GENERAL STEEL INDUSTRIES, INC.

November 4, 1968

At the request of Franklin D. Yoder, M. D., Director of the Illinois Department of Public Health, we have revised our AEC License No. 12-8271-1 to restrict the use of 80 curie/Co 60 source. The restriction is related only to the positioning of the source, source camera, and the control cable to reduce the possibility of exposure to personnel.

GENERAL PLAN -
 NEW BETATRON - G.S.I.

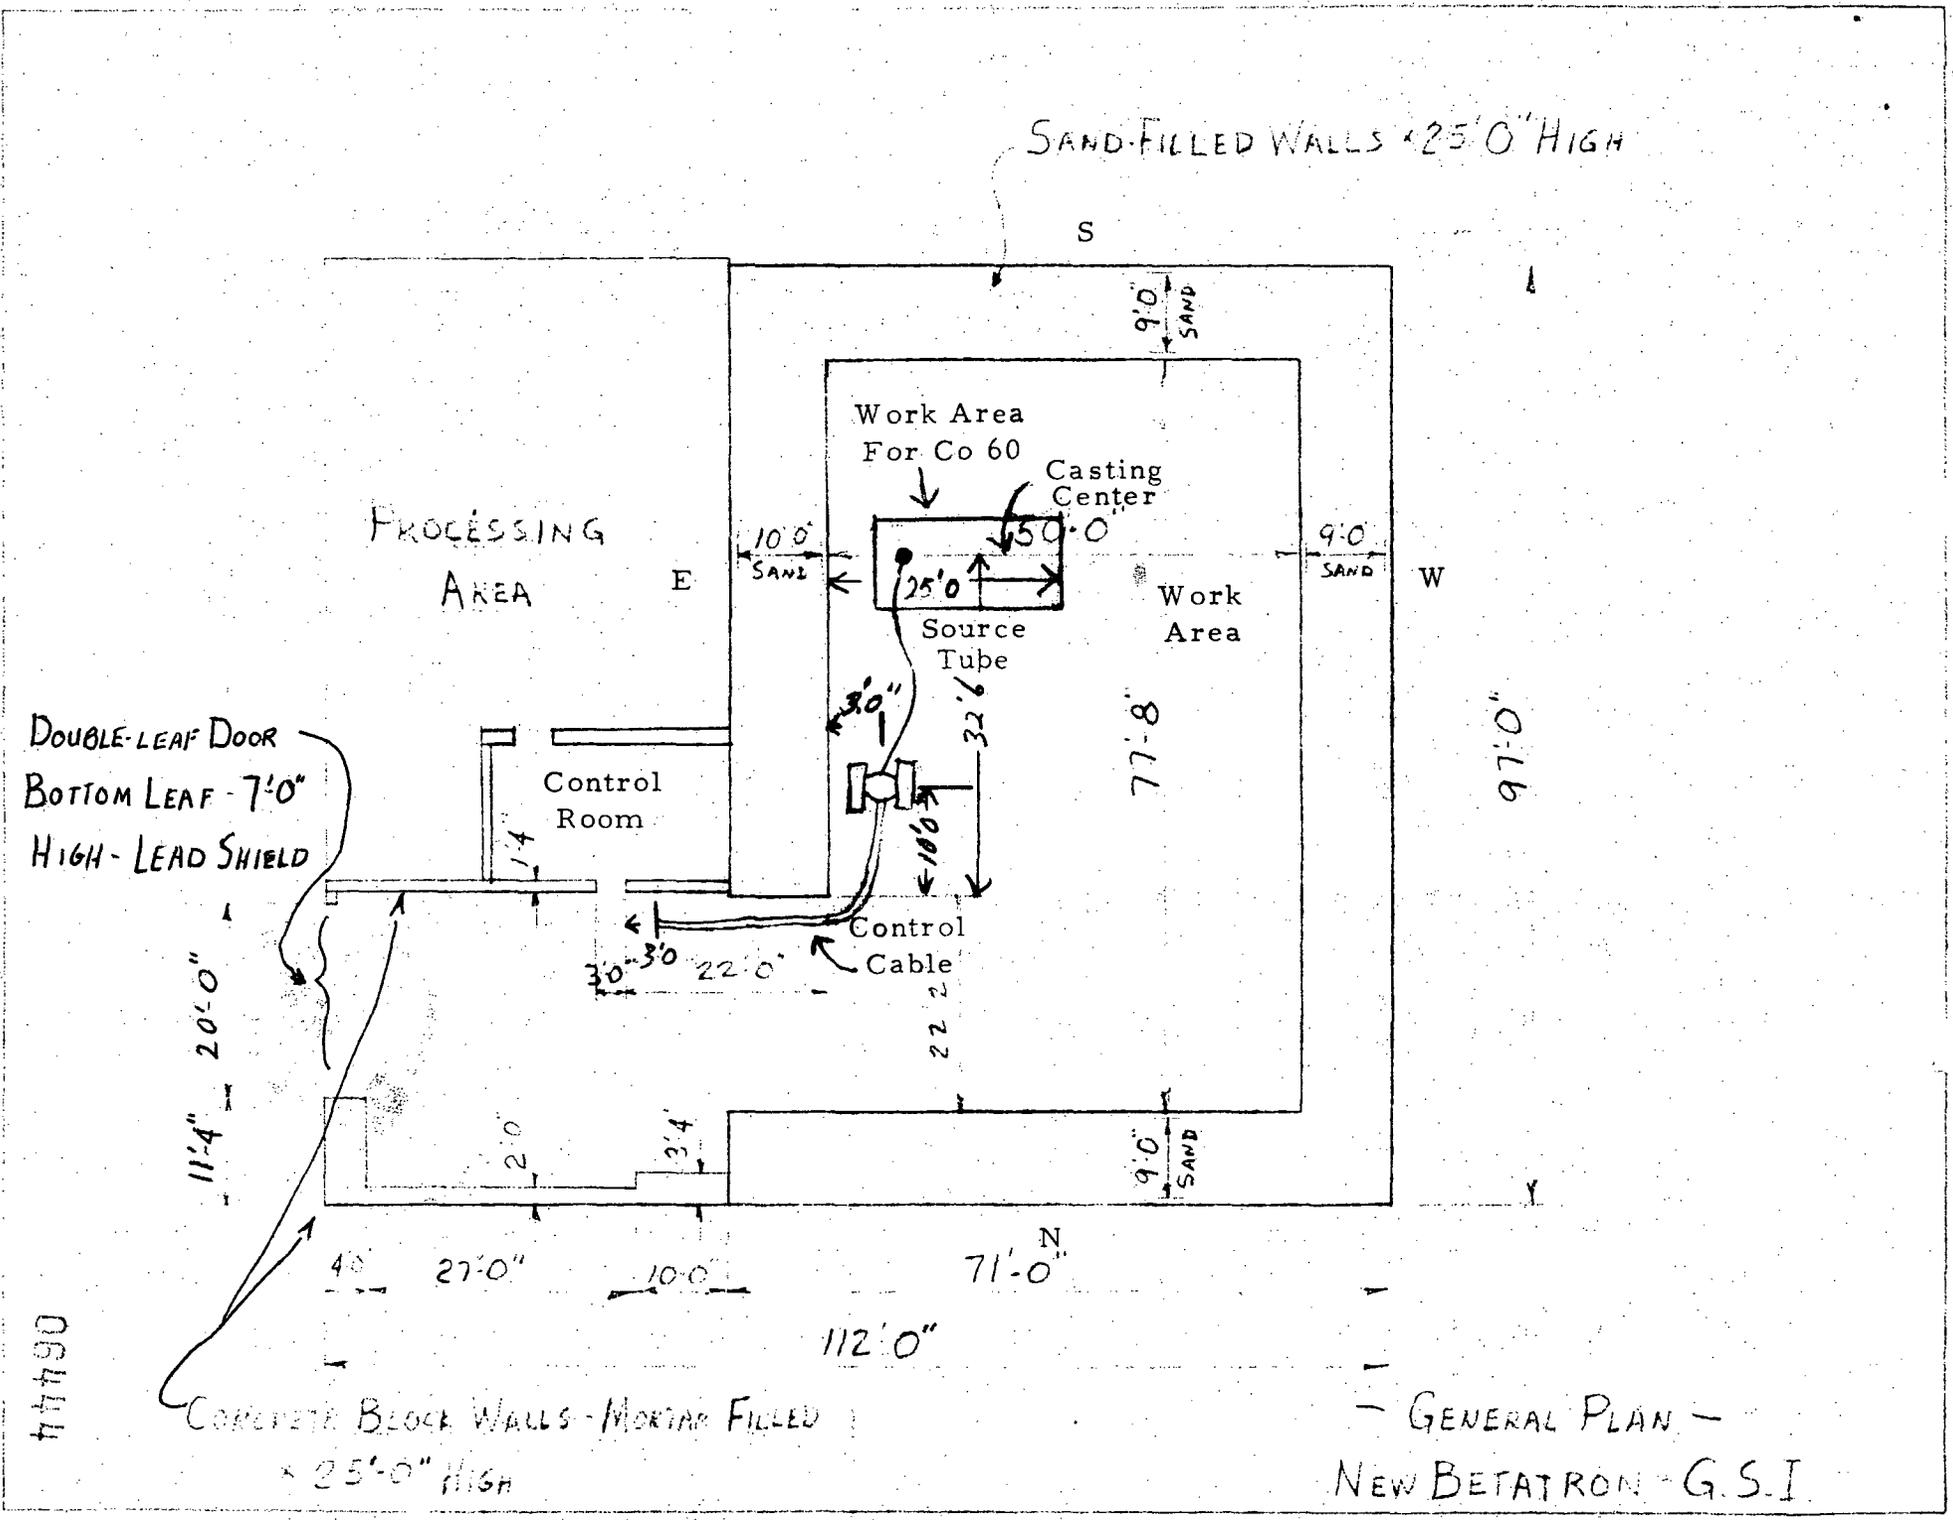
The change effects the sketch which is a part of Section 6(a), Description of Radiographic Facilities, and page 4 of Section 6(e), Operating and Emergency Procedures. The revised pages are attached.

3. Make the necessary entries in the utilization and survey log.
4. Always place the casting as far south as the handling crane will permit, approximately 54' from the north wall. The casting will be as close as is practicable to the east wall. Set up the unexposed film and fix the position of the source tube. Make certain the source tube is firmly fixed in the position required and that any angle in the tube is not too sharp to prevent movement of the source within the tube. The Co60 camera will be set approximately 3' from the east wall and 32' from the north wall. The control crank unit will be 3' from the entrance door to the control room.

6. Unlock the Radionic's camera device.
7. Have casting and camera located so that control cable may be operated from the corridor behind the 10'0" thick sand filled wall separating the radiographic area from the control area in the corridor. The control cable shall be behind this shielding at all time while the camera is in use. Observe the source position indicator.
